**FLOODPLAIN DEVELOPMENT PERMIT #851-24-00623-PLNG  
MAUCK**

<b>Request:</b>	A Floodplain Development Permit for the development of a commercial building and boat ramp.
<b>Location:</b>	The subject property is accessed via Cape Kiwanda Drive, a County road, and is designated as Tax Lot 5000, of Section 19CC of Township 4 South, Range 10 West of the Willamette Meridian, Tillamook County, Oregon
<b>Zone:</b>	Pacific City/Woods Neighborhood Commercial (PCW-C1) & Estuary Conservation 1 (EC1) Zone
<b>Applicant/ Property Owner:</b>	Benjamin Mauck, 16755 NW Elliot Rd, Portland, OR 97231

**FLOODPLAIN DEVELOPMENT PERMIT REQUEST  
851-24-000623-PLNG:  
MAUCK – COMMERCIAL BUILDING/BOAT RAMP**

**ADMINISTRATIVE DECISION & STAFF REPORT**

Plot Plan  
1/8" = 1' R

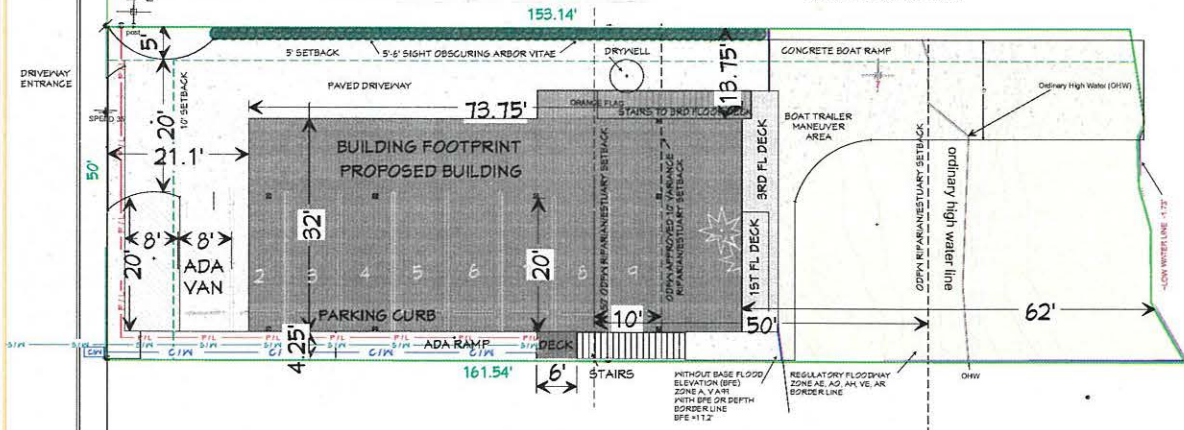
- Site plan:
  - Locations of existing trees/vegetation (indicate removal, if applicable), location and description of materials to be stored onsite during and/or after development, location and quantity of fill, grade and excavation activities, location of any restoration activities.

- ***See updated A-4 Plot plan for existing tree/vegetation locations, and A3 for grading activities.***
  - A fence is detailed in the application description, but is not depicted on the site plan.

- ***The final grading plan now shows a net cut and removal of 230 cubic yards, taking into account the paved parking and boat ramp areas. See A-3 Cross Sections and A-4 Plot plan for details. No fences are used in the updated design.***

- In 'Other' category, identify area for boat ramp.
  - Confirm if project includes any fill or dredging within estuary boundaries.
  - ***See updated A-4 Plot plan for boat ramp location and design. No fill or dredging to occur.***

Image taken from  
34905 Cape Kiwanda  
Drive, the house  
immediately adjacent  
to proposed boat ramp.

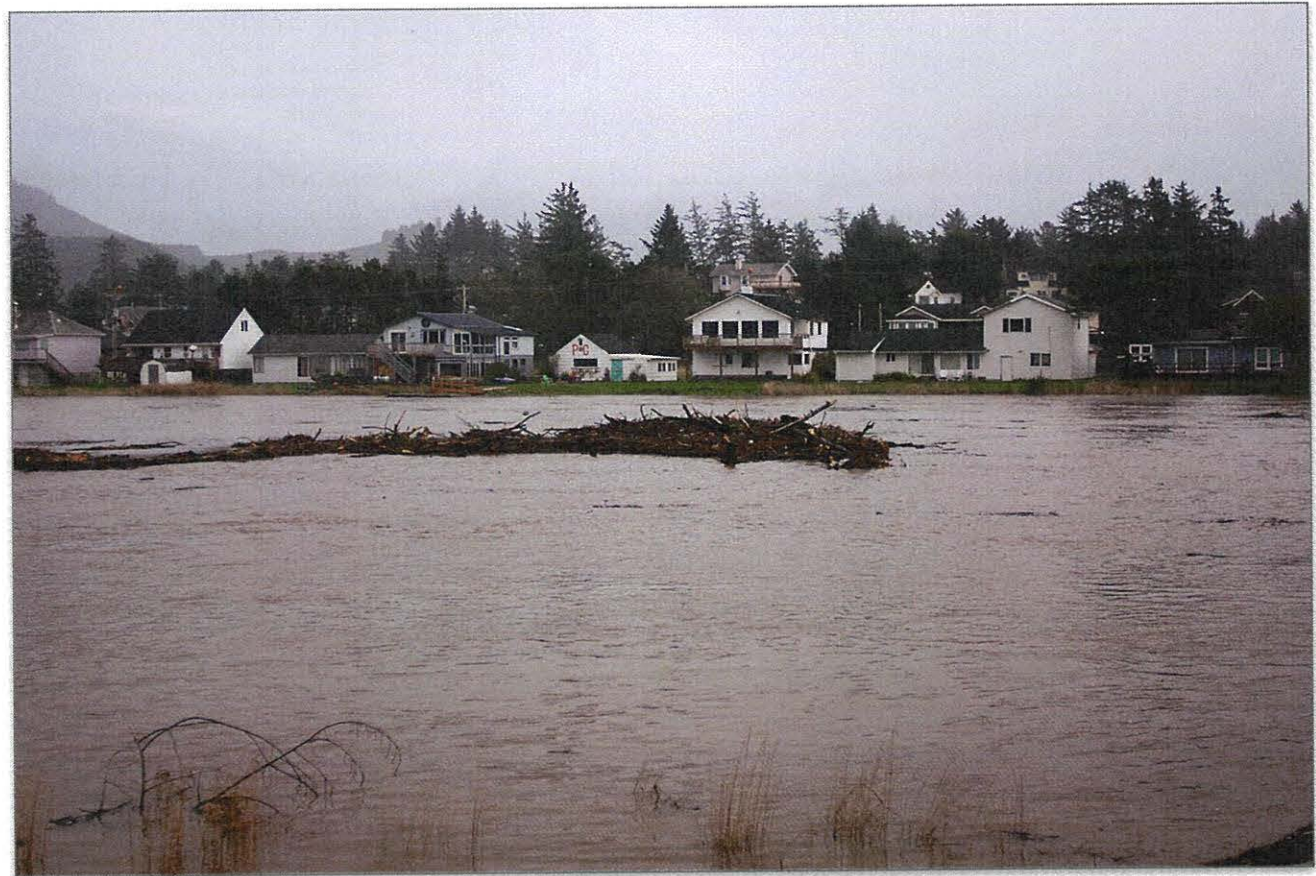
Looking south showing  
flooding impact on  
residence 34905 and  
proposed building site.

Image taken from  
34905 Cape Kiwanda  
Drive. The house  
immediately adjacent  
to proposed boat ramp.

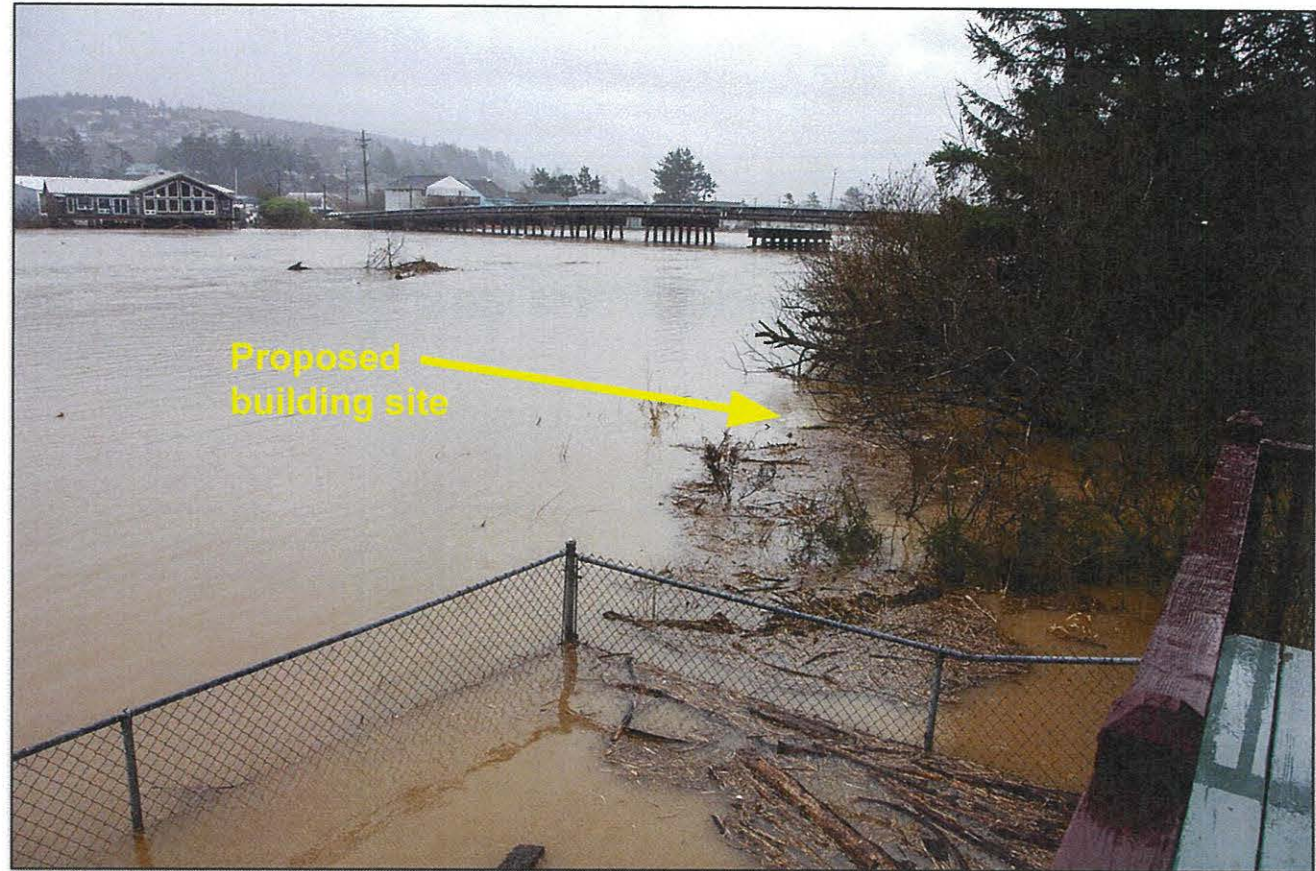
Looking north showing  
flooding impact on  
residences 34905 and  
34885
